<b>ITEM: 6.3</b>	<b>REPORT SUMMARY MINOR VARIANCE APPLICATION FILE NUMBER A012/25</b>
------------------	--

## MINOR VARIANCE APPLICATION FILE NUMBER A012/25

<b>CITY WARD #:</b>	1
<b>APPLICANT:</b>	Patrizia Tucci & John Pasquariello
<b>AGENT:</b>	Michael Persechini (Blue Grove Engineering Group)
<b>PROPERTY:</b>	50 Sierra Court, Maple ON
<b>ZONING DESIGNATION:</b>	See below.
<b>VAUGHAN OFFICIAL PLAN (2010) DESIGNATION:</b>	Vaughan Official Plan 2010 ('VOP 2010'): "Low Rise Residential"
<b>RELATED DEVELOPMENT APPLICATIONS:</b>	N/A
<b>PURPOSE OF APPLICATION:</b>	Relief from the Zoning By-law is being requested to permit a residential accessory structure (pool house) in the rear yard.

**SHEET TITLE:** PROPOSED ELEVATION

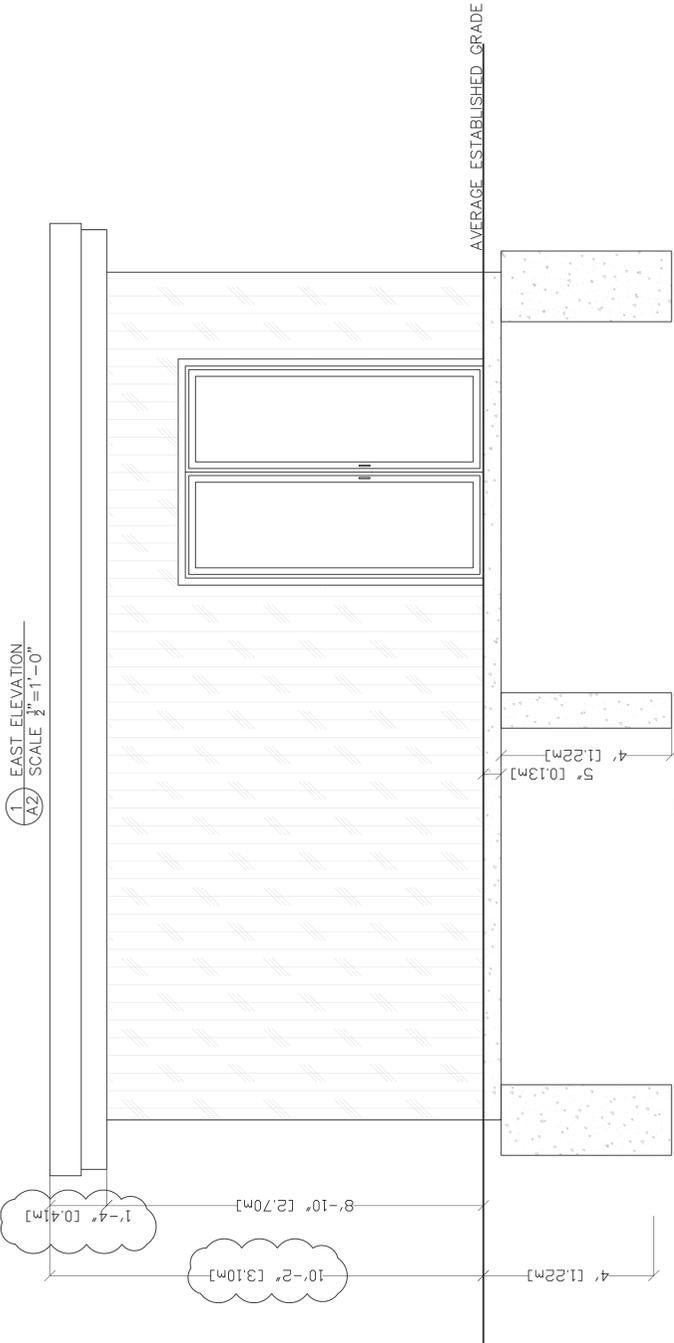
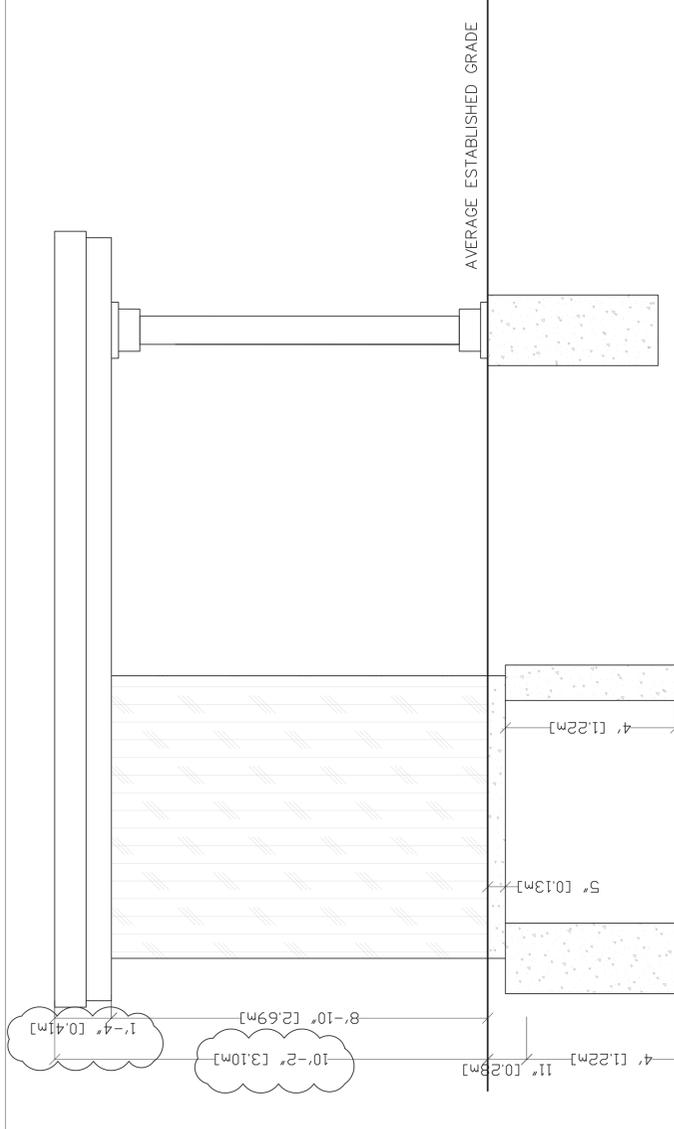
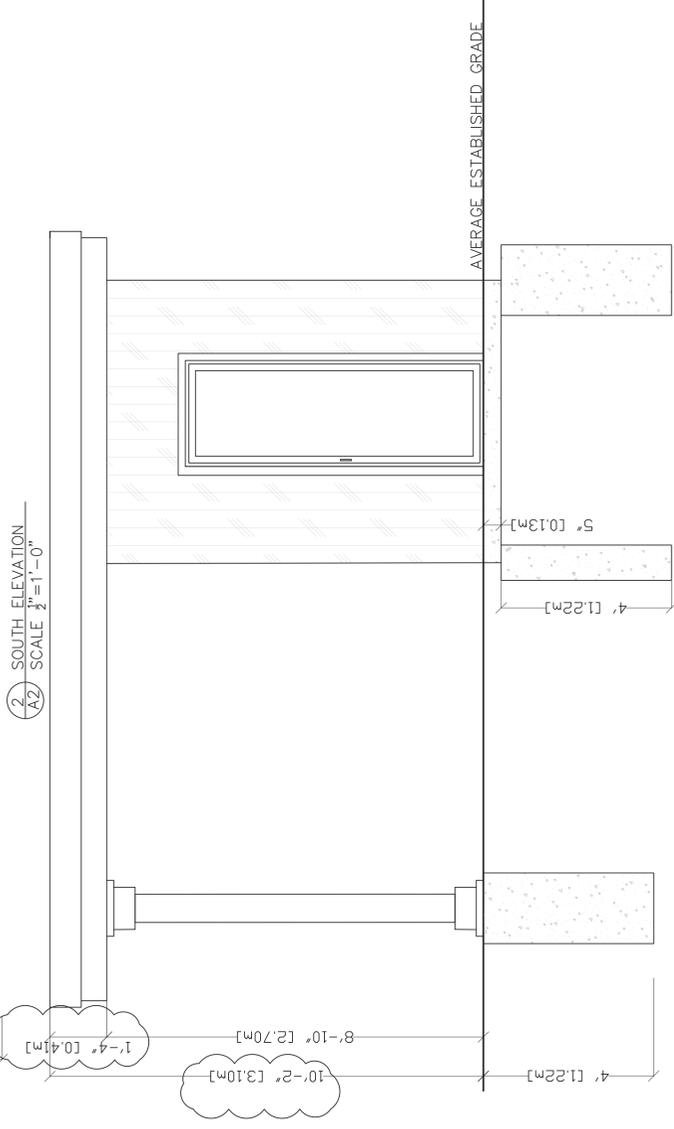
General Comments	
1	The applicant shall be advised that additional variances may be required upon review of detailed drawing for building permit/site plan approval.
2	The submitted elevation drawings provide established grade as defined in section 3.0 of zoning by-law 001 – 2021 as amended. The applicant shall confirm that the height is based on the existing grades.
